SEWAGE DISPOSAL SYSTEM

MARYLAND STATE DEPARTMENT OF HEALTH

SUBDIVISION Kalmia Farms ROAD 14722 Betula Way LOT 3, Section 2

Location Survey
14722 BETULA WAY
KALMIA FARMS SECT. 2

PROPOSED
NEW WOODEN
DECK ADDITION

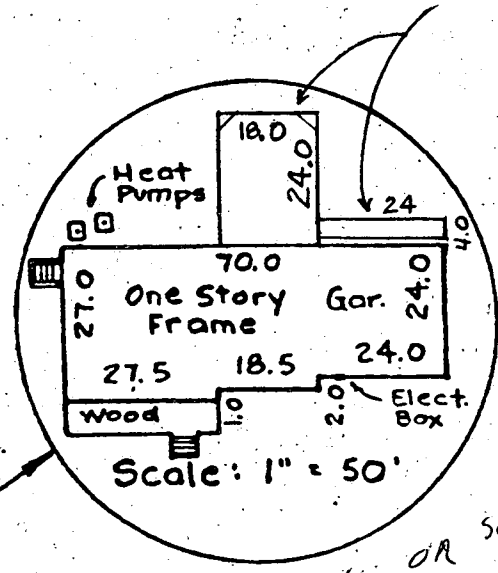
NO IMPACT ON WELL OR SEPTIC
OK TO PROCEED,
8/14/89 *Carlene*

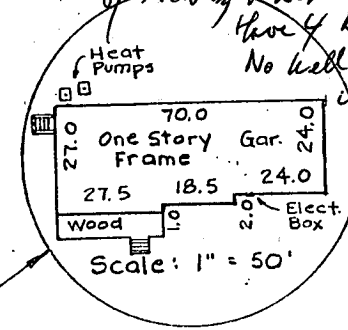
Increase of House from 4 to 5 Bedrooms, Previous Bldg added approved in 1989 (Deck) No changes at that time) Has 1500 gal ST. OK for 5 bdr Original System installed 14% larger than 4 bdr requirement of time. Contractor says shell is actual a Sanroom enlargement of existing Bldg - will only have 4 bdr as permitted. No well or Septic impact approved. Recommend Approval. 4/3/97

PLOT PLAN

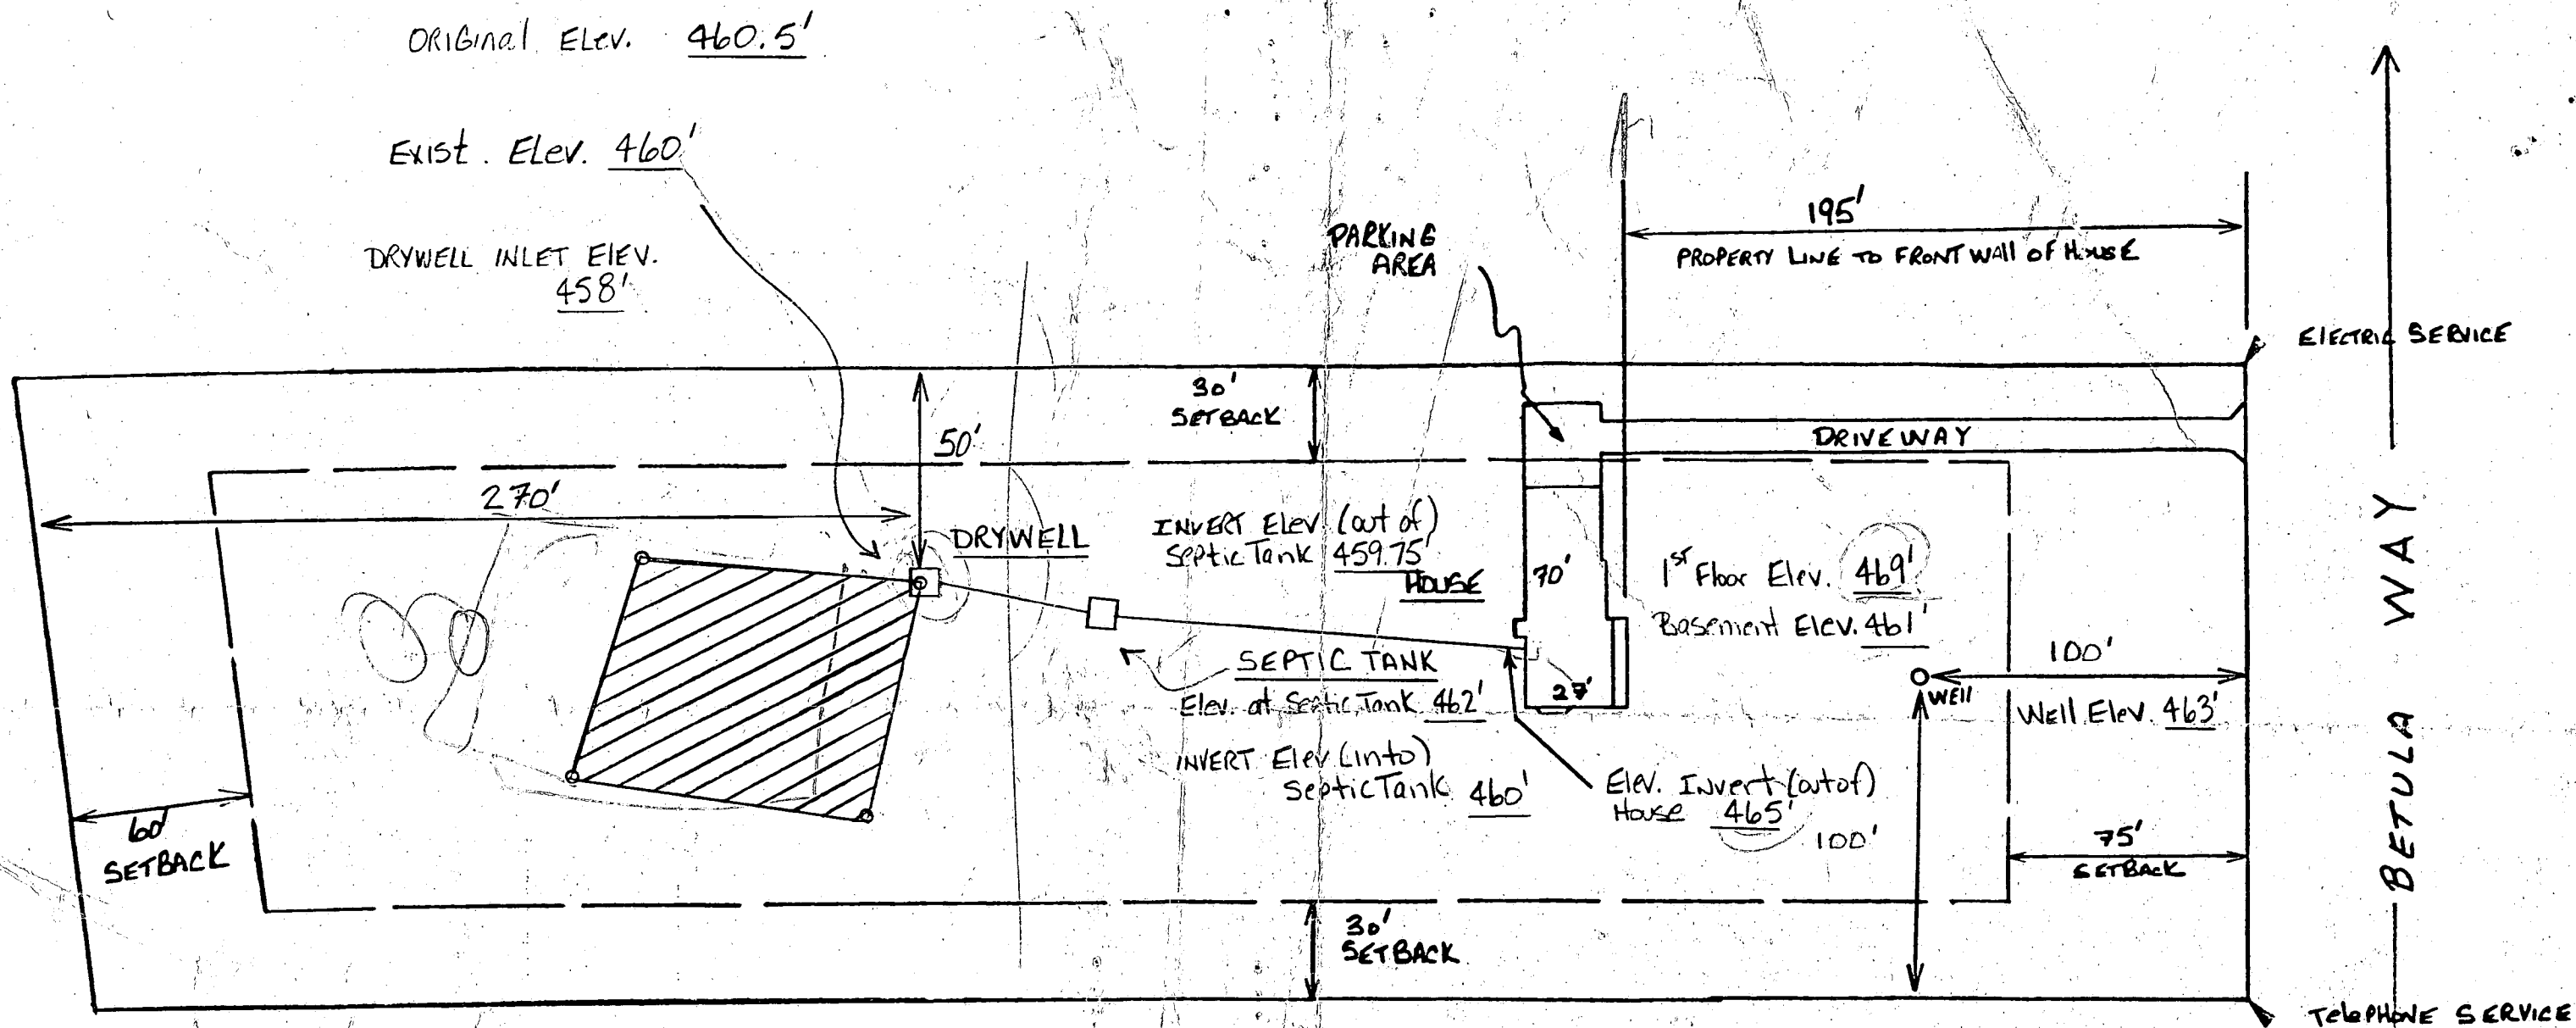
4/5/84
Stepdown and cleanout
in house sewer req. Wall
house sewer is toward west
to J
